## Field Service Application

REFERANS: FSA 202513

SUBJECT: Gen 2.0 SCR Harness Touch Condition

<b>Subject</b>	SCR Harness Touching To Interdar Cooling Bracket
<b>Model</b>	F-Max & F-Line GEN2 Retarder / Interdar Vehicles
<b>Summary</b>	14398 and 12A690 ECU harness branch touching or closing to interdar cooling bracket. This causes harness damage. Convolute tubing and tape will be applied to protect and prevent contact areas for damage.

Zoomed view of the area mentioned in Step 2:

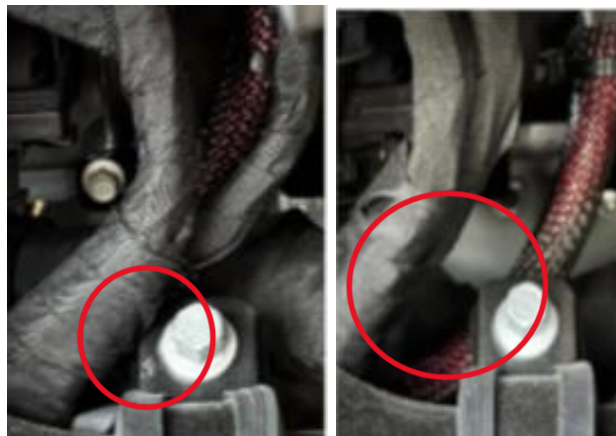
1. The cabin will be tilted.
2. Check the marked area on the engine on the passenger side.

Touching

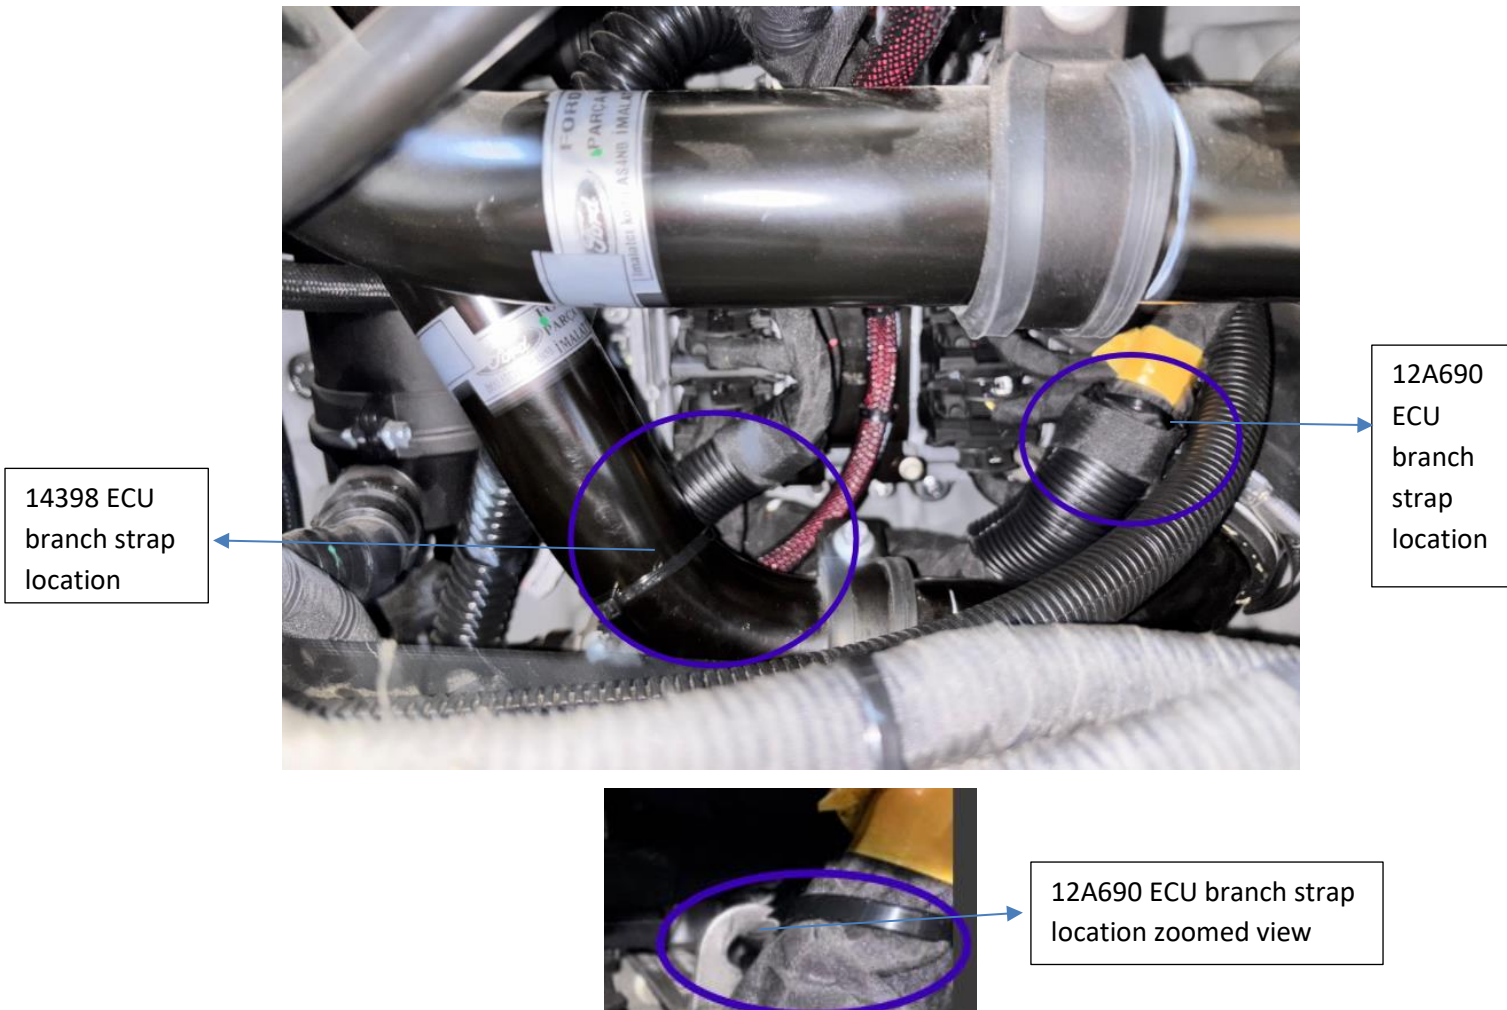
3. In the harness positioning mentioned in Step 2:  
If the relevant harness is in contact with the bracket or appears as shown in the photo below like touching or approaching to bracket, proceed to the next step for the definition of corrective actions.  
(Vehicles with approaching scr lines have potential close contact and should also be included to avoid future risk.)

- Cut the convolute tube with part number **GC46-9A288-AA** to a size sufficient to cover the contact area (cutting must be done using side cutters or scissors).
- Wrap the cut convolute tube around the area where the harness contacts the bracket.
- After applying the convolute tubing, to prevent it from slipping off, cut a section of cloth tape **FC46-1A303-AA** (used on the harness) and tightly tape it over the wrap (cutting must be done using side cutters or scissors).
- After these steps are completed, the area should appear as shown in the photo below.

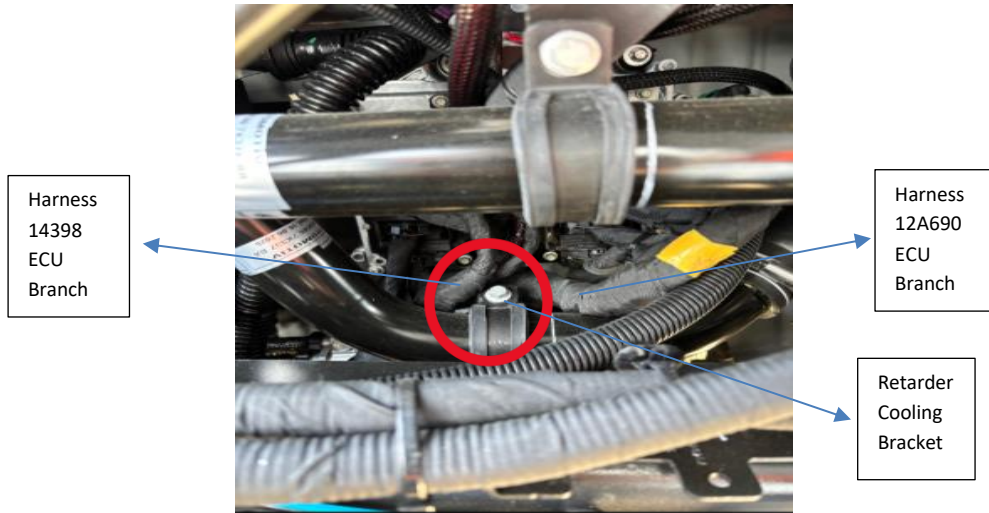
- 1) Tilt the cabin.
- 2) Remove the part marked below – GC46 6M002 EA (Cover plate close to the ECU).

7) Re-assemble the removed part marked below - GC46 6M002 EA.

Touching

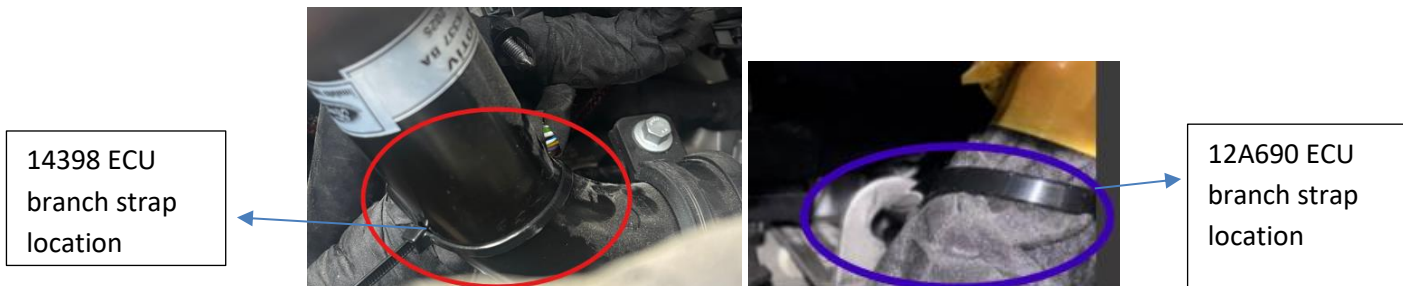
If the relevant harness is in contact with the bracket or appears as shown in the photo below like touching or approaching to bracket, proceed to the next step for the definition of corrective actions. (Vehicles with potential close contact should also be included to avoid future risk.)

- Cut the convolute tupe with part number **GC46-9A288-AA** to a size sufficient to cover the contact area (cutting must be done using side cutters or scissors).
- Wrap the cut convolute tupe around the area where the harness contacts the bracket.
- After applying the convolute tubing, to prevent it from slipping off, cut a section of cloth tape **FC46-1A303-AA** (used on the harness) and tightly tape it over the wrap (cutting must be done using side cutters or scissors).
- After these steps are completed, the area should appear as shown in the photo below.

14398 ECU  
branch strap  
location

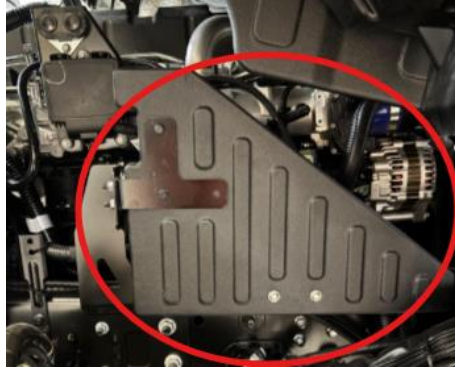
- 6) The 14398 and 12A690 convoluted tubed & taped wiring harness ECU branches should be strapped to move away from the bracket by connecting them to the same parts as FMAX described above by the plastic strap (**8C46-2D218-AA**).
